6.0 ADMINISTRATIVE CONTROLS6.1 ORGANIZATION

Amendment No. 10

Figure 6.1 Georgia Tech Organization for Management and Operation of the GTRR. (Amendment 11).

Figure 6.1 Georgia Tech Organization for Management and Operation of the GTRR.

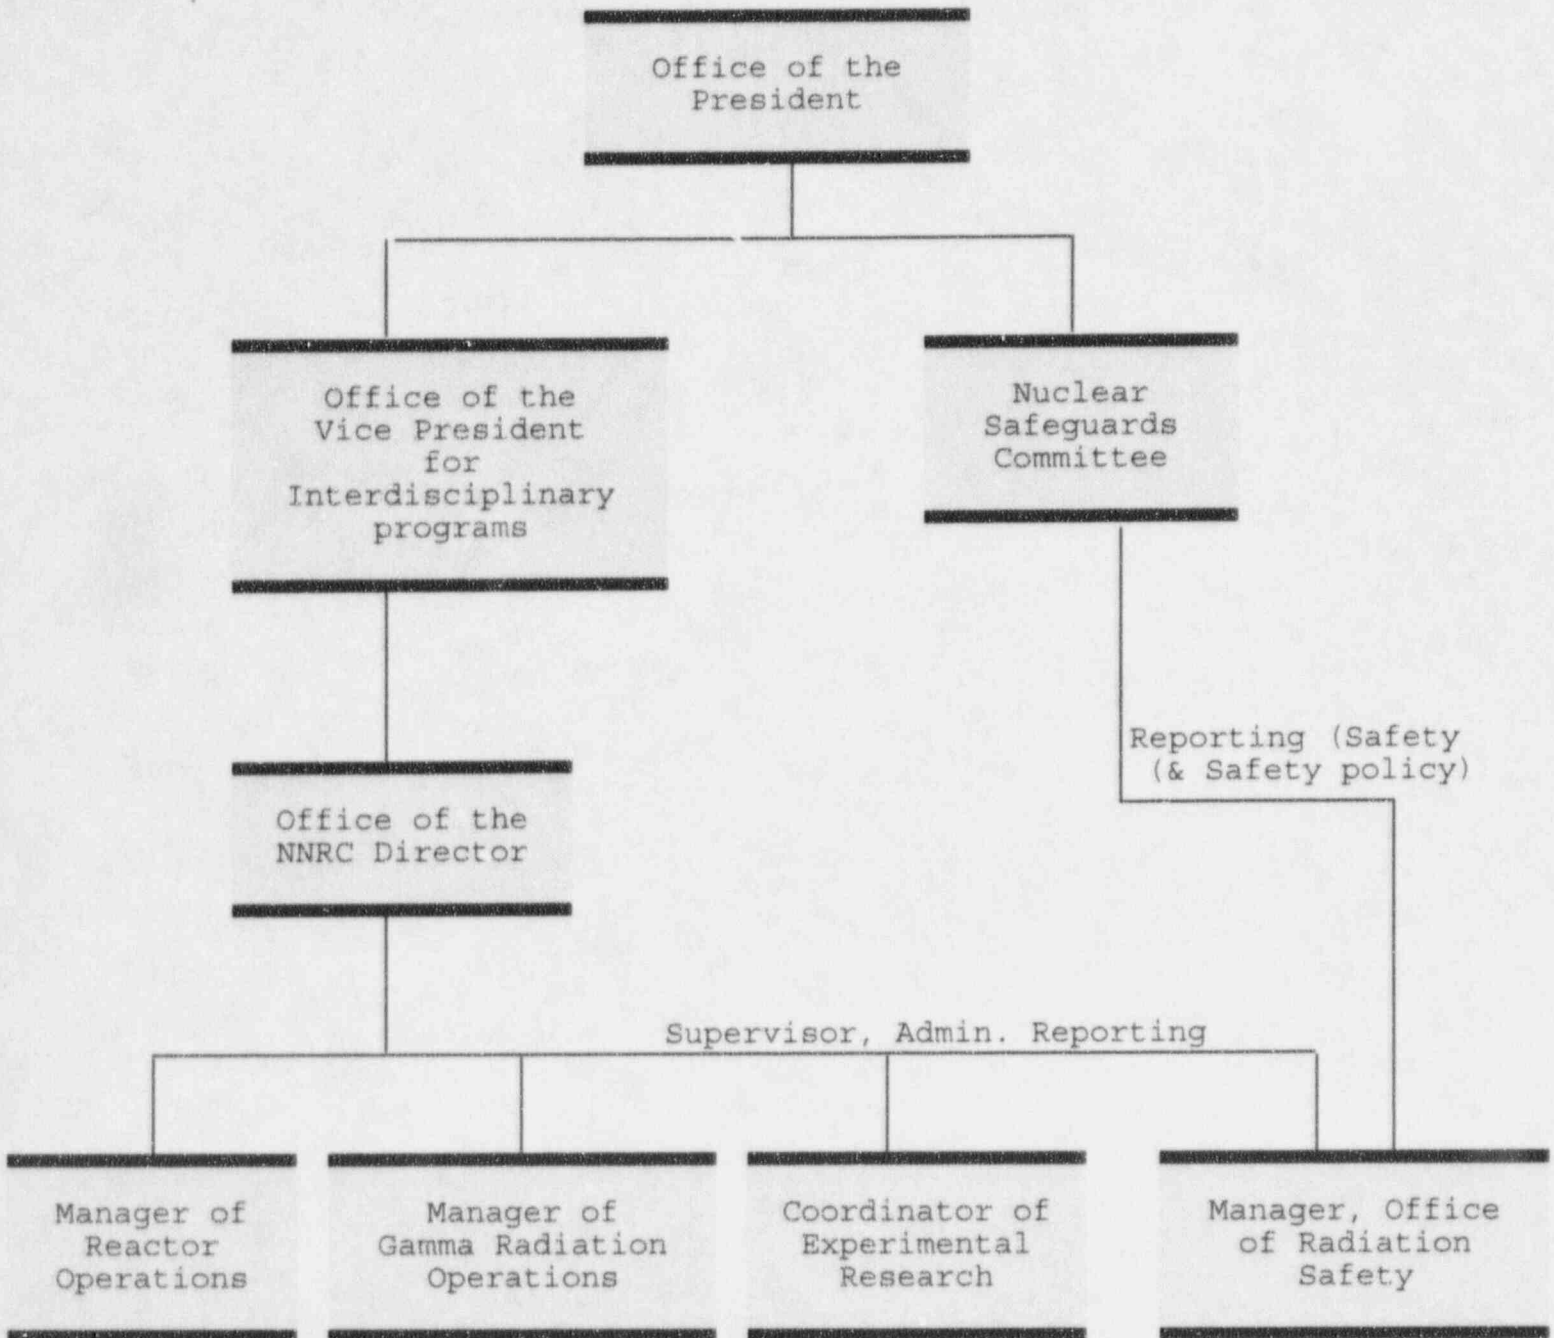
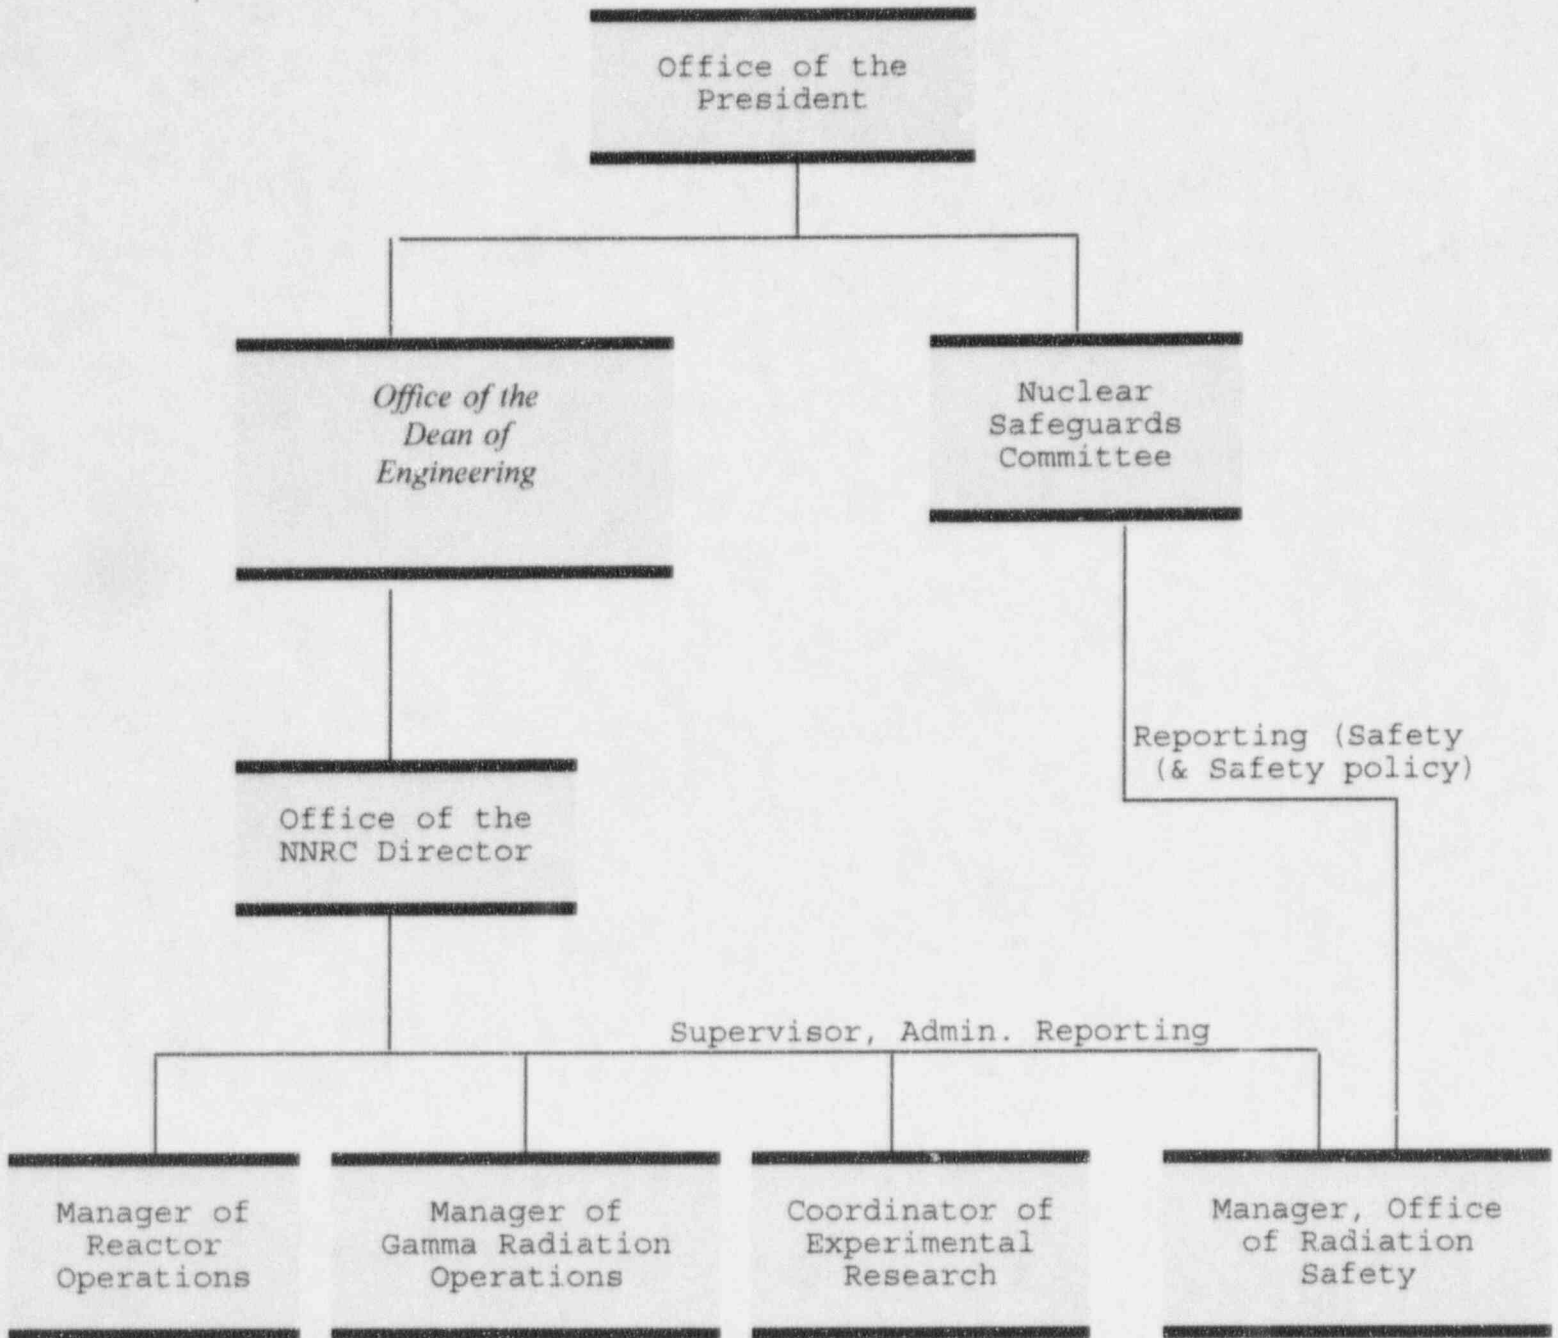
The Manager, Office of Radiation Safety, shall advise the Director, Nuclear Research Center, in matters pertaining to radiological safety. He/she has access to the ~~Vice President, Interdisciplinary Programs~~, and/or the President of the Institute as needed.

The Manager, Office of Radiation Safety, shall advise the Director, Nuclear Research Center, in matters pertaining to radiological safety. He/she has access to the Dean of Engineering and/or the President of the Institute as needed.
